**GE Hitachi Nuclear Energy**

Subject: **Response to Portion of NRC Request for Additional Information  
Letter No. 345 Related to ESBWR Design Certification Application  
– Site Characteristics - RAI Number 2.3-4 S06**

**Response to NRC RAI Letter No. 345  
Related to ESBWR Design Certification Application<sup>1</sup>**

**RAI Number 2.3-4 S06**

**Figure 2.3-4(1) Typical Sketch of Roof Drain**

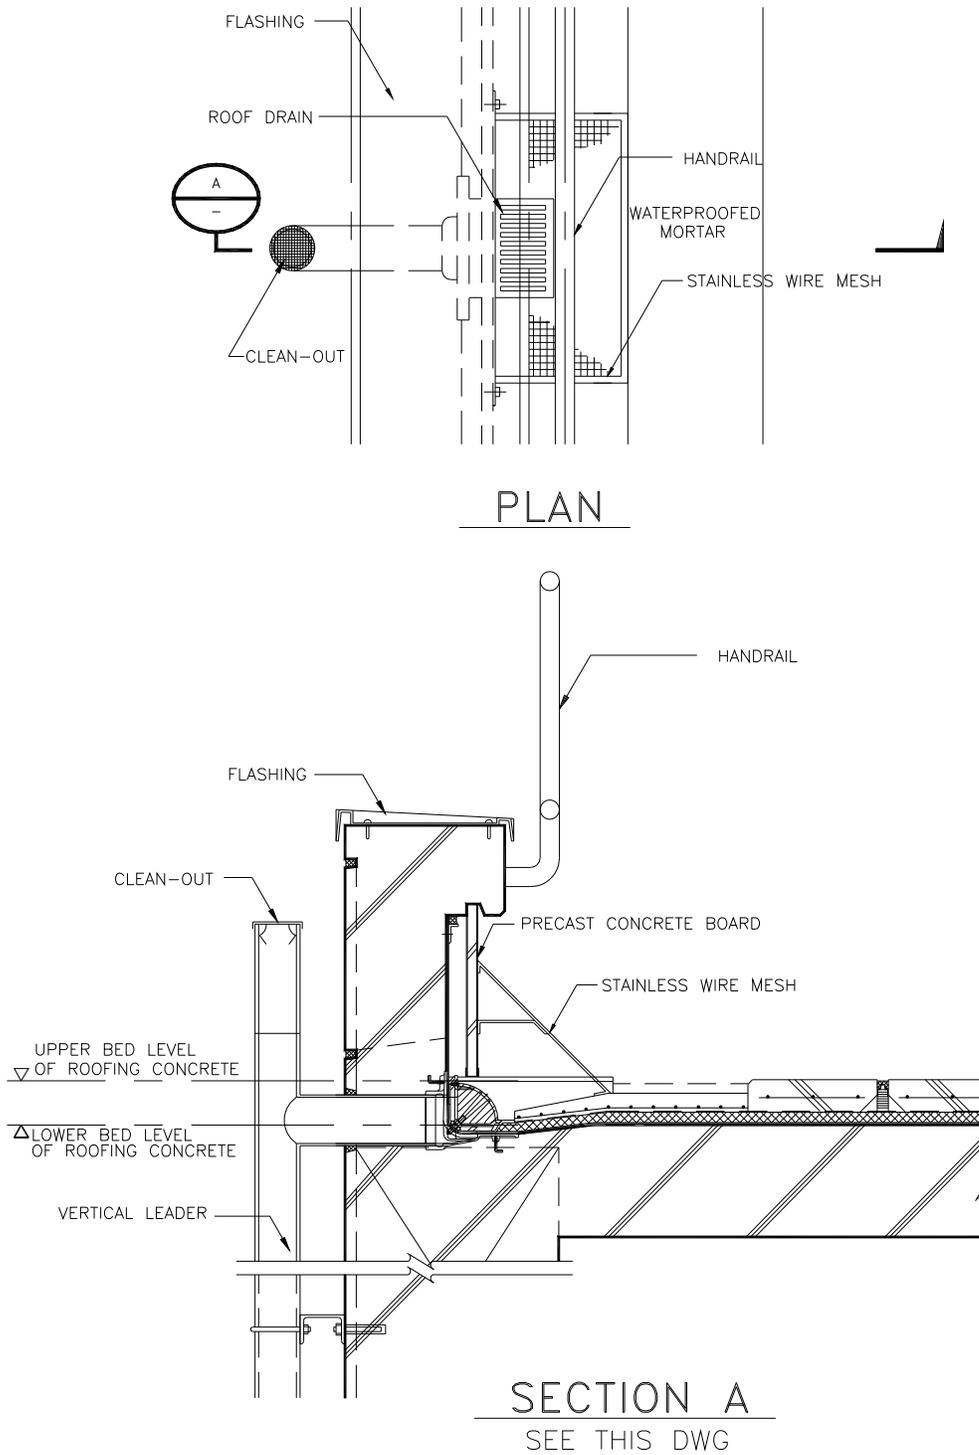
*Footnote 5 to DCD Tier 2 Table 2.0-1 states that the roof scuppers and drains are designed independently to limit water accumulation on the roof to no more than 100 mm (4 in) during PMWP conditions. Please provide details of the design of the roof scuppers and drains demonstrating that an antecedent 100-year recurrence interval ground level snow pack of 2394 Pa (50 lb/ft<sup>2</sup>) will not clog both the roof scuppers and drains and prevent no more than 100 mm (4 in) of water accumulating on the roof.*

In the ESBWR Standard Plant, roofs are provided with two independent drainage systems. The roof drains form the primary drainage system and the scuppers form the secondary drainage system. As required by the International Plumbing Code (invoked by IBC-2003) and ASCE 7-02, only the blockage of the primary system is postulated when designing the secondary system and for calculating the rain load on the roof.

Figures 2.3-4(1) and (2) show typical sketches of the roof drain and overflow scupper. The design of the roof scuppers and drains follows ASCE 7-02. The elevation of the overflow scupper is set such that the average water depth does not exceed 100 mm (4 in.) in case the roof drains are clogged by snow, ice, or other obstructions.
